Queen Anne Ave

412 Queen Anne Avenue N, Seattle, WA 98109

RECOMMENDATION
APRIL 2020
PROJECT # 3033479-LU

1a ARCHITECTURAL CONCEPT DIAGRAM DEVELOPMENT

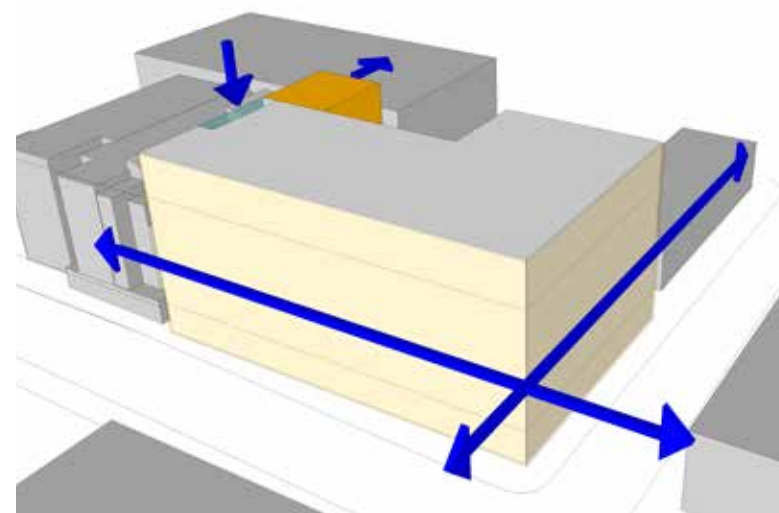
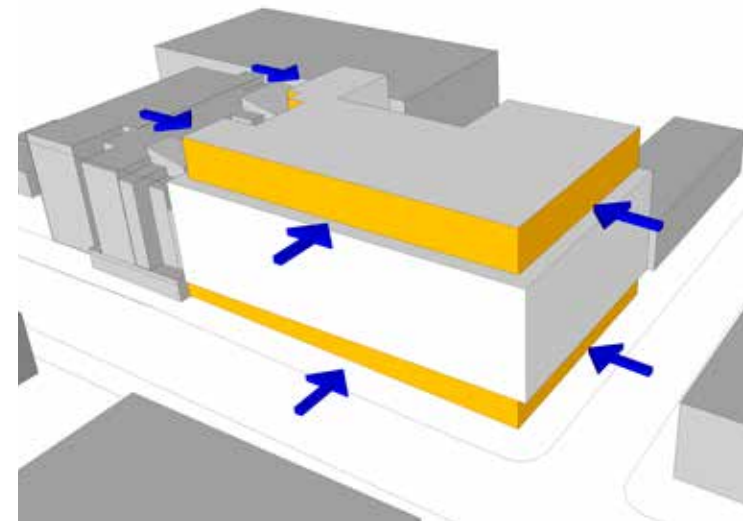
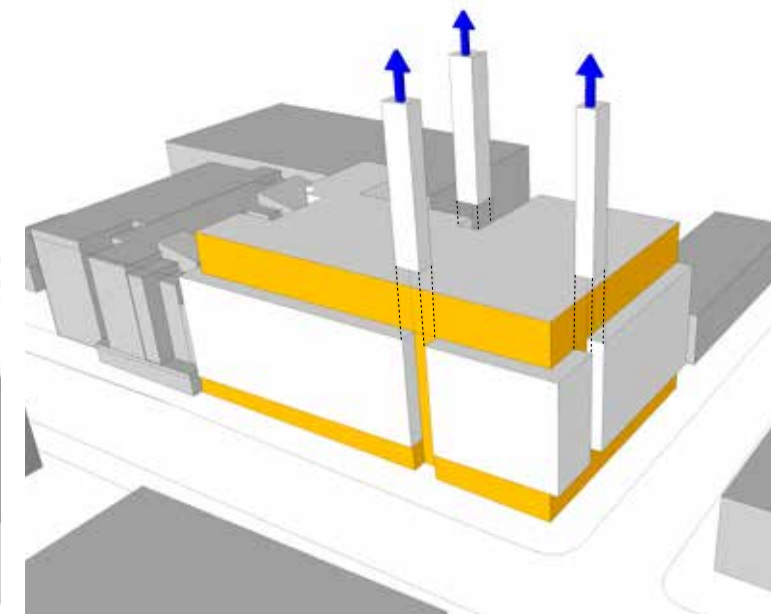
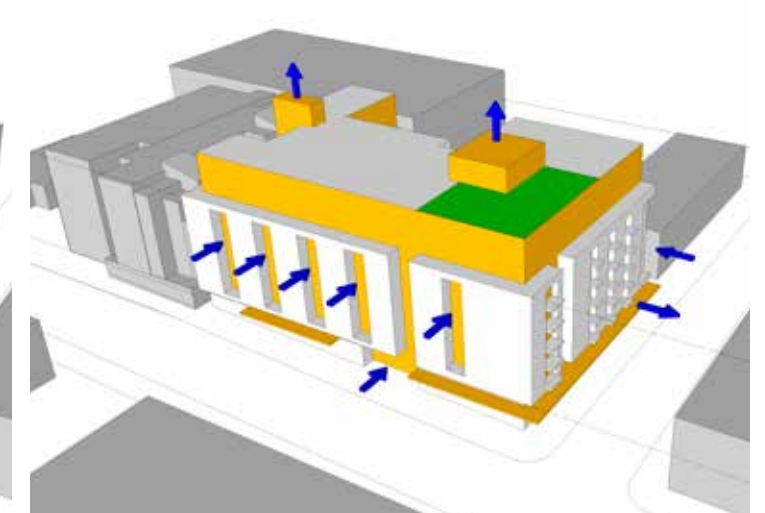
- 1a** 1a: The Board questioned the design progression from context analysis to the preferred massing. The Board commented that a clear illustration of the architectural concept was not provided, and worried the project moved too quickly into thinking about the details of the building before solidifying the conceptual driver(s) for the project. The Board was concerned with how the project would progress without an underlying concept to anchor the design. (DC2 Architectural Concept)
- 1b** 1b: At the next meeting the Board expects to see strong parti/concept diagram, which addresses the guidance provided below and creates a clear framework that will anchor the project moving forward. (DC2 Architectural Concept)

RESPONSE: The project team reviewed the project's concept phase and worked to clarify the project's concept parti. Since the Early Design Guidance meeting, the surface parking lot site to the north was added to the project area, and the proposed massing expanded to the north creating a new zero lot line condition. A modified massing diagram based on the Option C scheme was developed and became the conceptual anchor for the further development of the building's placement on the site and relationship to its surrounding neighborhood. This parti, in combination with the Uptown and Seattle Design Guidelines and the Board comments, helped to form the framework for the underlining building concept; and provided the organization which resulted in the current design.

The refined parti diagram started with a simple form set to the urban edges of Queen Anne Ave N and Harrison Street. The northern portion of the mass was extended to match the depth of the adjacent building, and a notch was created to correspond with the northern building's courtyard. The mass was then divided into 3 horizontal segments, with the upper and lower segments being recessed along the two street fronts to provide for a distinct zoning of the mass and increased pedestrian space at street level. The recess at the upper levels is used to reduce the perceived building scale creating a massing relationship to the surrounding context. The upper section is also recessed along the northern property line to reduce the massing impact on the adjacent building. The middle section was then further defined by the use of vertical slots which subdivide the zone into clearly definable segments emphasizing connections between the levels, entry points, and corner elements. Lastly the residential entry and roof terrace are defined within the massing to highlight connections and links through the building and to surrounding views. Recessed deck elements are added to further articulate the middle zone creating modulation and rhythm along the street facades.

DESIGN RESPONSE: MASSING OPTIONS

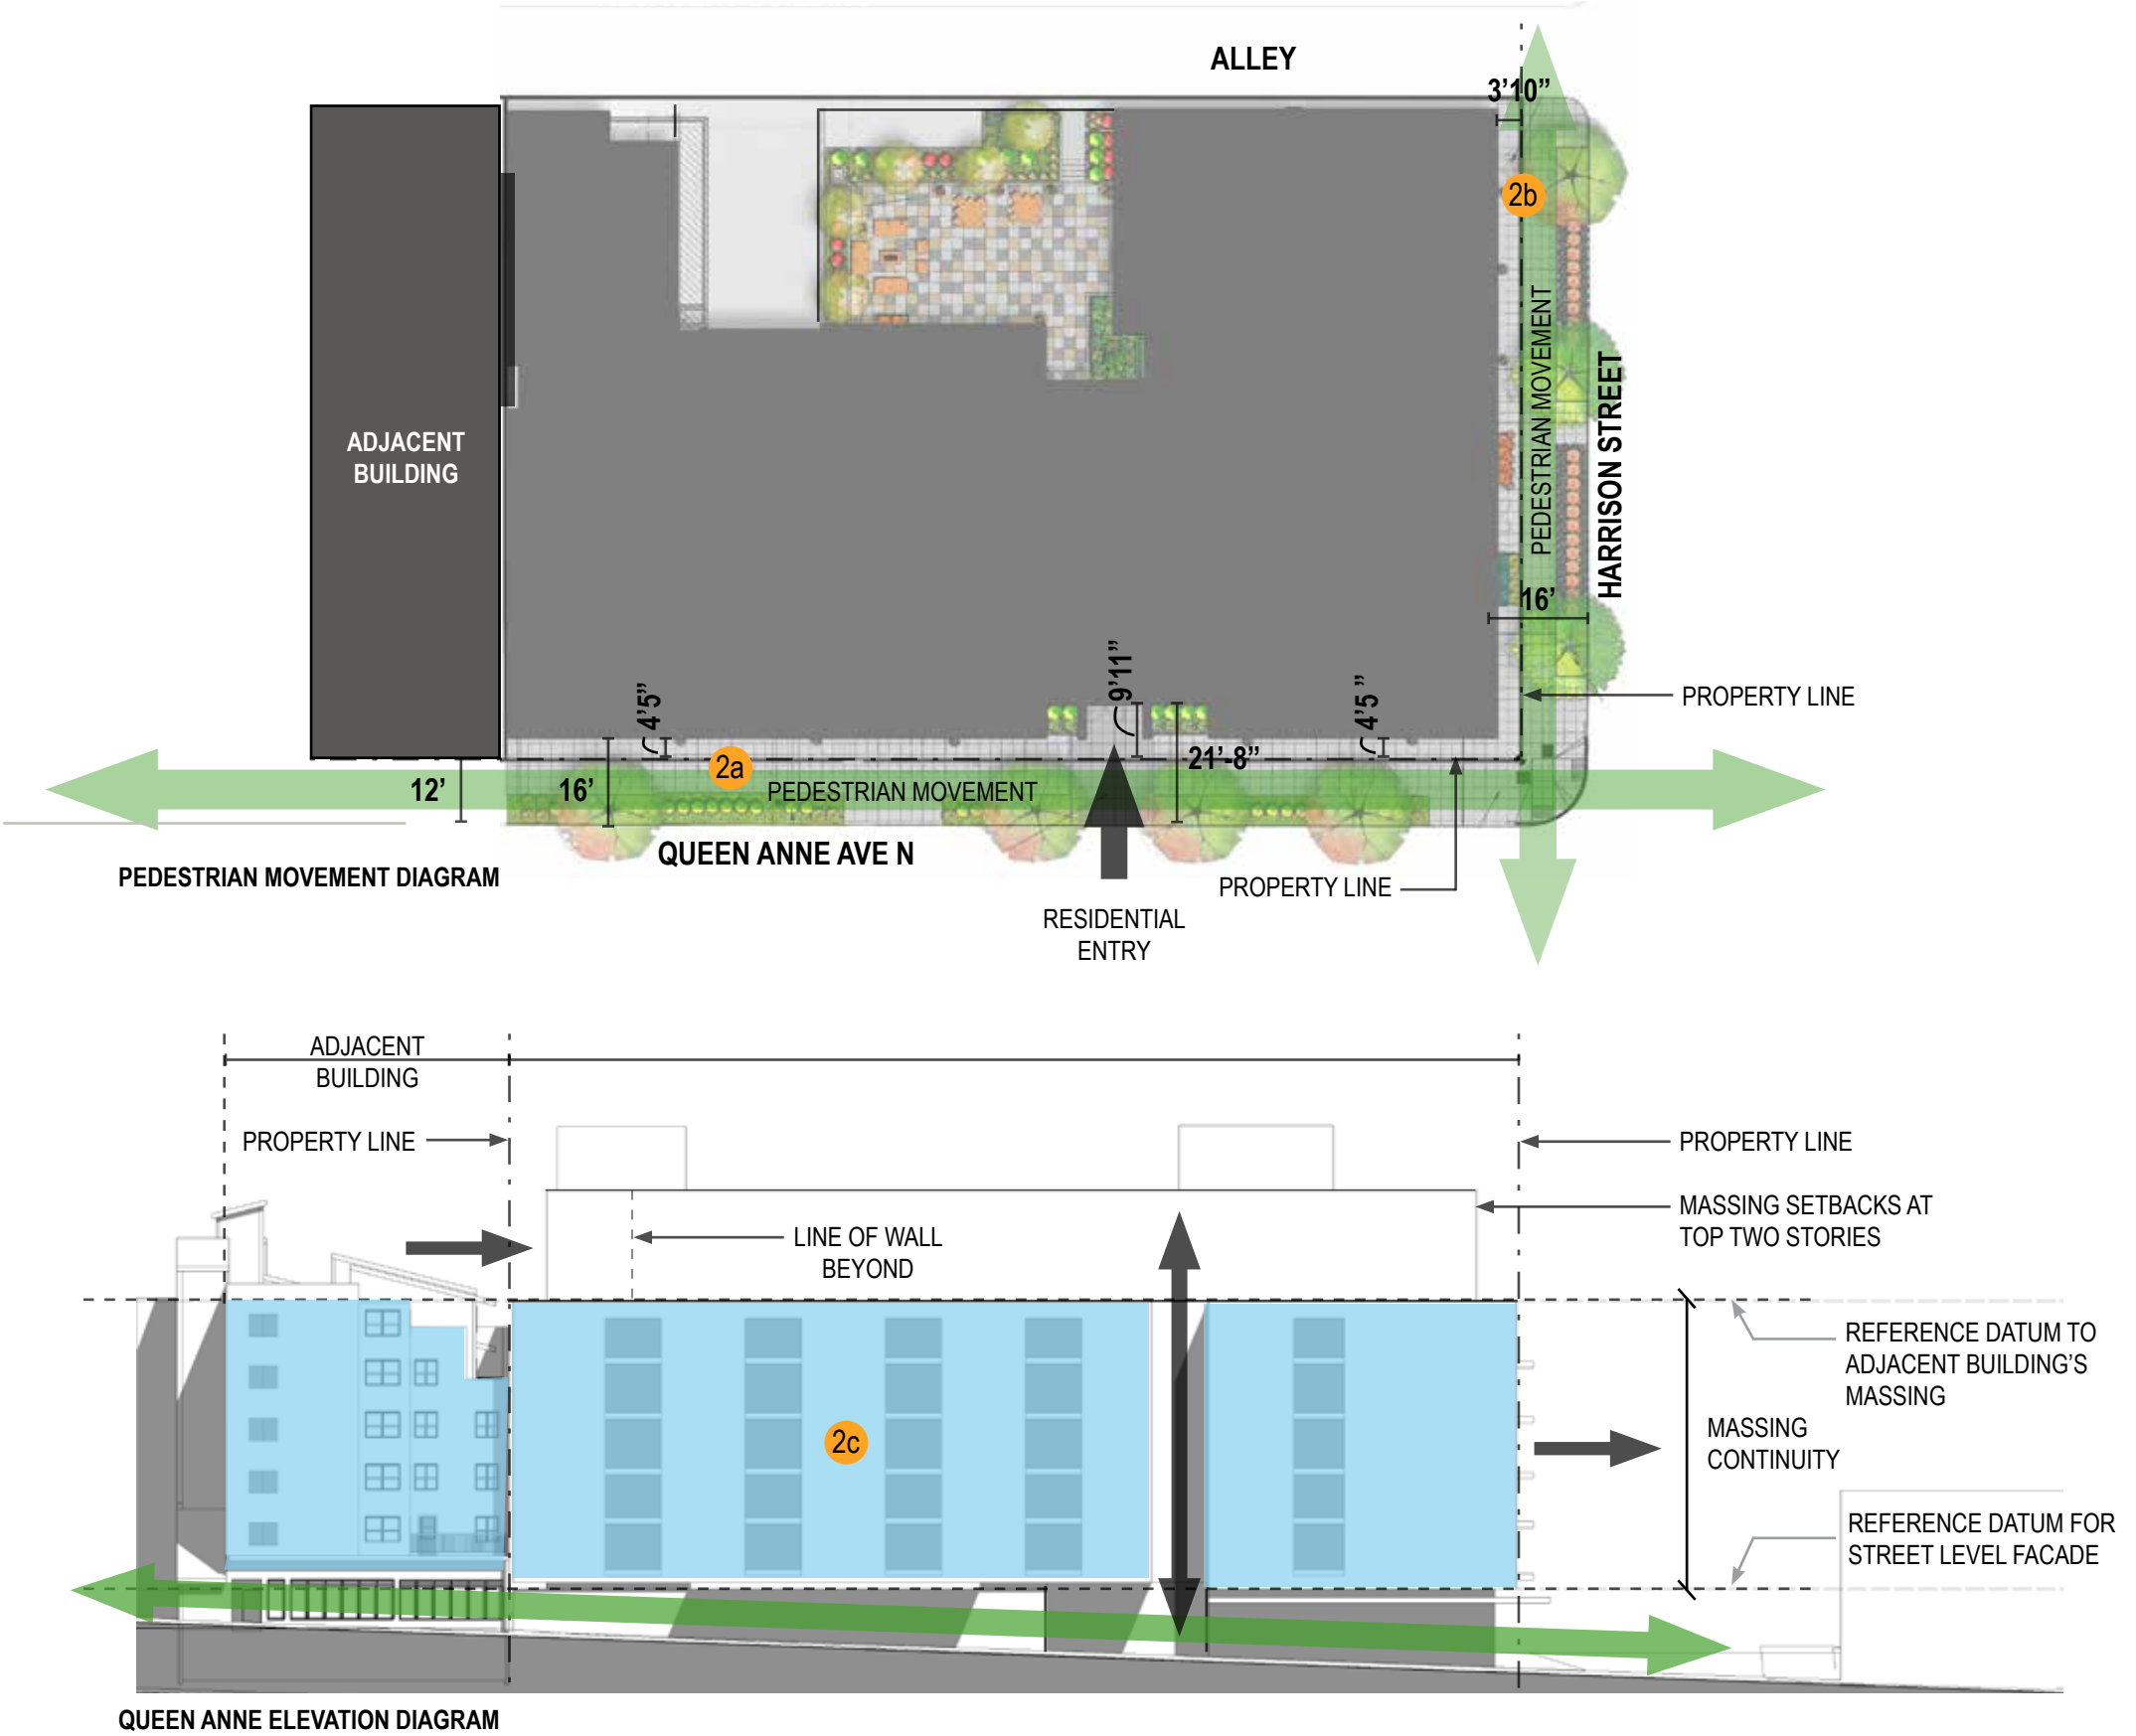
2a 2a: Option A. The Board acknowledged pulling back a portion of the massing along Queen Anne Avenue seemed to reduce the height bulk and scale impacts along the longer street frontage, as well as reducing height bulk and scale impacts along the narrower Queen Anne Ave N right-of-way. The Board supported the wider ground-level setbacks, upper level setbacks, location of the residential entry, and retail at the corner. (DC2-A-2. Reducing Perceived Mass)

2b 2b: Option B. There was some support for pulling back massing along Harrison street to create a courtyard as shown on page 17 of the initial massing diagram. However, the final B massing form pushed back out to the street, contradicting this conceptual massing move, which supported the applicant's narrative for a pedestrian oriented response at street-level. The Board was less supportive of moving the lobby entry to Harrison Street. (PL1-3Pedestrian Volumes and Amenities)

2c 2c: Option C. The Board acknowledged the merits in the L-shaped building response, which seemed the most historically appropriate response by creating a continuous street-wall. The Board supported the upper-level setbacks, location of residential entry and retail, and recessed balconies. (DC2-A Massing, CS3-A Emphasizing Positive Neighborhood Attributes)

RESPONSE: Although Option A was not selected, the proposal response looked at some of the merits of this diagram and the Board's comments by recessing the main street level façade an additional 1'-0" back from the 3'-6" required street ROW dedication, for a total minimum of 4'-5" additional width to the existing sidewalk (only 3'-6" proposed at EDG). The residential entry was further recessed, emphasizing its location within the Queen Anne Ave N façade.

RESPONSE: Although Option B was not selected, the proposal looked at the merits of this diagram and considered the Board's comments about the setback along Harrison St and responded by recessing the street level façade 3'-10" (an additional 2'-4" from proposed at EDG) back from the property line, increasing the sidewalk width as a move to increase the area allocated to pedestrian movement from Key Arena.

RESPONSE: The revised Option C concept maintains the historic street-wall concept while also responding to the scale and massing of the new adjacent building condition. Setbacks were maintained at the upper floor level to help reduce the overall building mass, the middle section maintains the historic street wall nature of the Uptown neighborhood, and the street level façades recess providing for increased pedestrian movement and interactions. Additional upper level setbacks were introduced along the northern property line to reduce the massing impact on the adjacent building's internal courtyard.

DESIGN RESPONSE: MASSING OPTIONS

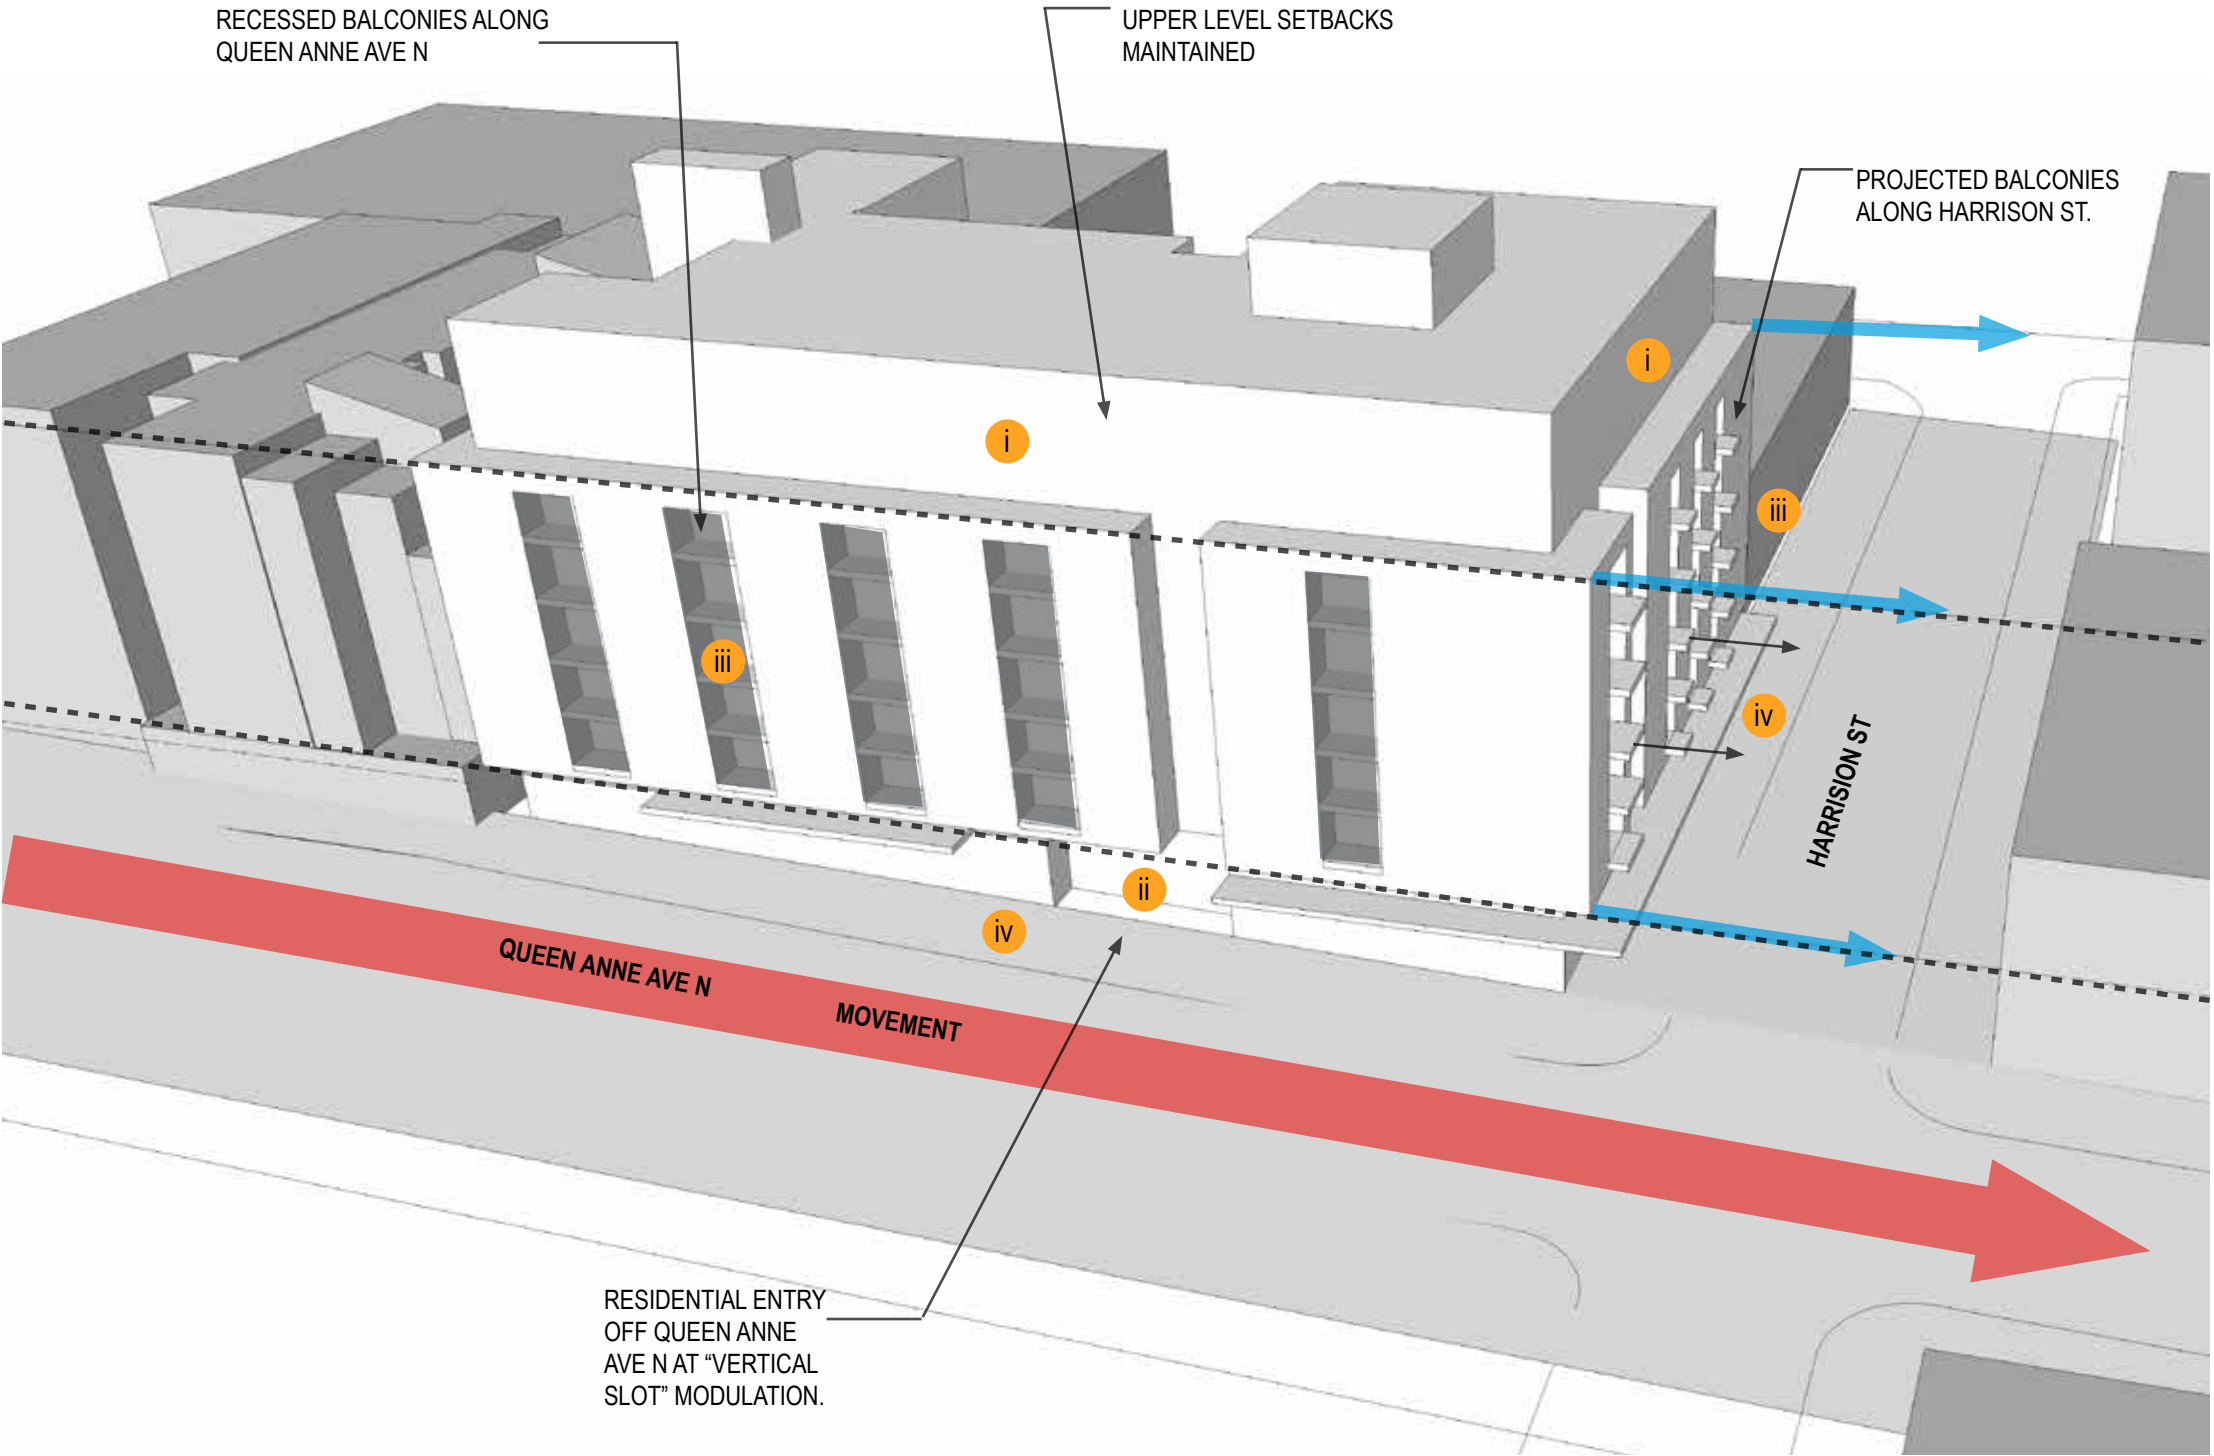
- 2d. Board Supported Option. After a thoughtful discussion, the Board voted 3-1 to move the project forward with Option C and provided the following guidance:
- i. Maintain the upper level setbacks along Harrison St and Queen Anne Ave N. (DC2-A Massing)

- ii. The Board supported the residential lobby on Queen Anne Ave N. (PL3-A Entries)

- iii. Regarding the balconies, the Board noted they could be supportive of street projecting balconies on one façade and recessed balconies on another façade, so long as there is consistency in concept and a clear relationship between the two. Balconies should read as an actual modulation element, a legible void, as shown in the massing diagrams. The Board noted the recessed expression as critical to establishing the rhythm along the Queen Anne Ave N façade as illustrated by the diagrams, rather than the sketch which filled the void and diminished this expression. (CS2-D Height, Bulk, and Scale, DC2-A-2. Reducing Perceived Mass, DC2-B-1. Façade Composition)

- iv. The Board was concerned with the setbacks provided at street-level in Option C, as the reduced setback seemed to contradict the design team’s focus on accommodating event day pedestrian traffic resulting from Key Arena activities. The Board noted setbacks in Options A and B were more consistent with this concept. At the next meeting, the Board would like to see studies of how the design would provide greater space along the street for retail and pedestrians through increased setbacks or other moves. In addition, the Board would like information further documenting the anticipated increase in pedestrian volumes. (PL1-3Pedestrian Volumes and Amenities)

RESPONSE: Upper level setbacks along both street facades are provide as well as along the interior lot lineto the North.

RESPONSE: Residential Lobby remains on Queen Anne Ave N. The entry use is recessed at the street level. The recess has a direct relationship with the “vertical slot” in the main tower massing of the building, reinforcing the entry location within the project.

RESPONSE: The building responds to the slope and high traffic movement down Queen Anne Ave N. Recessed balcony slots are used to create a rhythm along Queen Anne but also to give a sense of protection and separation from the high traffic and noise of the street. Where as along the quieter Harrison Street both the middle mass and balconies cantilever out over the sidewalk as if they are slipping down the hill, responding to the movement on Queen Anne. In both cases, the accent material and window alignment are simplified creating a clear rhythm along the street frontage and emphasizing the “void”. The voids created by the balconies read as part of this modulation providing shadow, rhythm and depth within the facades.

RESPONSE: The setbacks of both street level façades has been increase creating about a 16’ deep sidewalk area along both streets. This area will include street trees, planting strips, raised planters and wide walking areas. Large canopies provide weather protection along most of the street front facade. Please refer to sheet 14 for a study analysis of the anticipated urban foot traffic routes and mass transit opportunities.
